Anna Maria Island Beach Nourishment Project - Hardbottom Mitigation and Monitoring Plan

March 2001

Re: Revised Nearshore Hardbottom Monitoring Transect Lines and Proposed Nearshore Artificial Reef Monitoring Transects - Anna Maria Island Beach Renourishment Project, DEP JCP File No. 00393378-001-JC

Figure 1

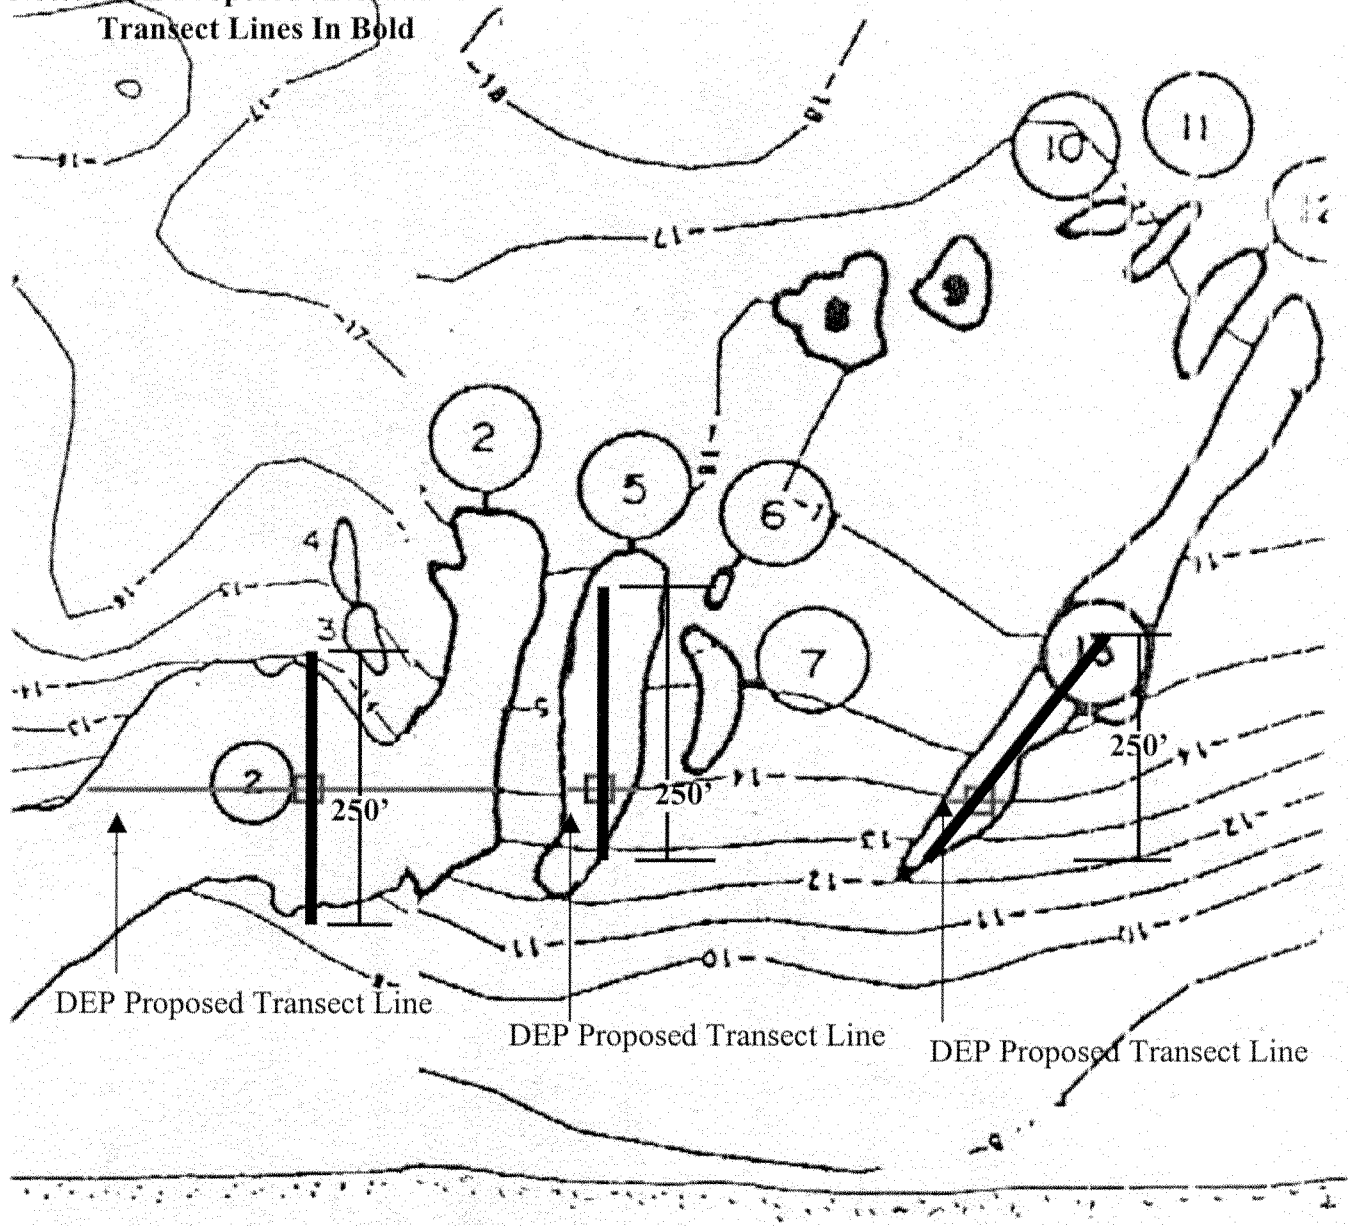
In response to your request for comments on the transect line monitoring requirements for the subject project, Coastal Planning and Engineering (CPE) proposes alternate transect line alignment to monitor nearshore hardbottom habitats. The Department of Environmental Protection (DEP) transect lines presented in the Intent to Issue run parallel across the nearshore hardbottom formations. CPE proposes to establish alternate transect alignments as depicted on Figures 1 and 2. CPE recommends that the transect lines commence at the nearshore edge of the persistent pre-construction hardbottom formation. The transect will then extend seaward, or along the alignment of the hardbottom, a distance of 250 feet, or to the seaward edge of hardbottom, whichever is greater. Establishment of shore-perpendicular or angled alignments along the hardbottom habitats will provide better delineation of equilibrium toe of fill movement in relation to the hardbottom features identified for monitoring. Please note that the hardbottom associated with Site #14 (Figure 2) was originally characterized as an irregular sand / rubble area. CPE will attempt to establish a transect line in this area, but the nature of the substrate will dictate the location and length of the line.

Note: CPE Proposed Alternative
Transect Lines In Bold

FIGURE 3

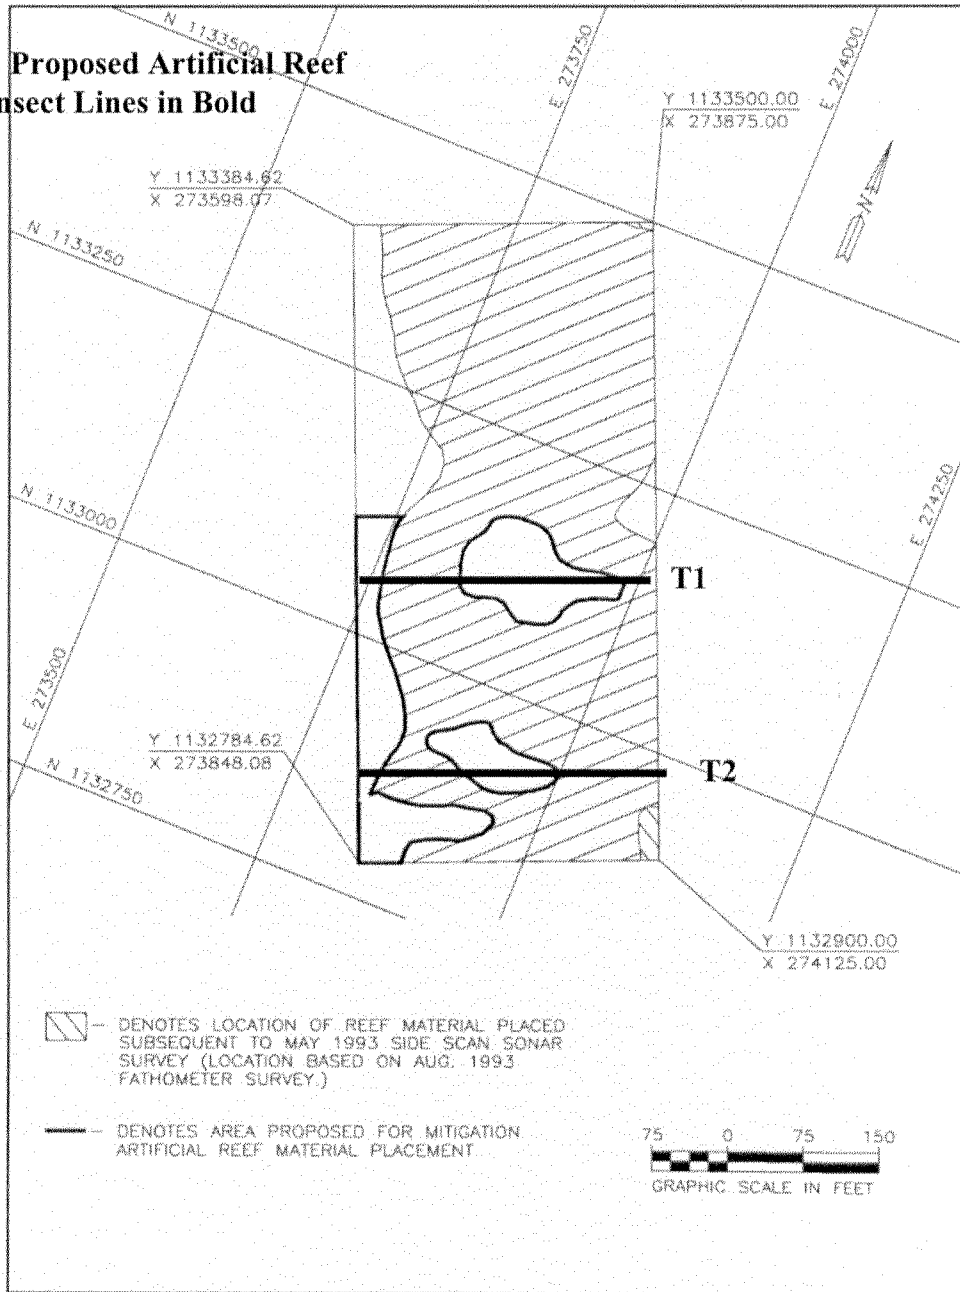
In response to the DEP's request for two proposed transect lines over the mitigative nearshore artificial reef, CPE proposes establishment of the lines as delineated in Figure 3. Transect line placement at these sites will allow investigators to document recruitment and colonization of the newly placed material in relation to existing material placed in conjunction with the 1992/1993 project. The western terminus of each transect will be located at the edge of the newly placed material and proceed in a generally easterly direction, over the two new artificial reef installations, and will terminate at a point, not less than 25 feet, east of the new material in an area of the reef constructed in 1992/1993.

**Note: CPE Proposed Artificial Reef
Transect Lines in Bold**
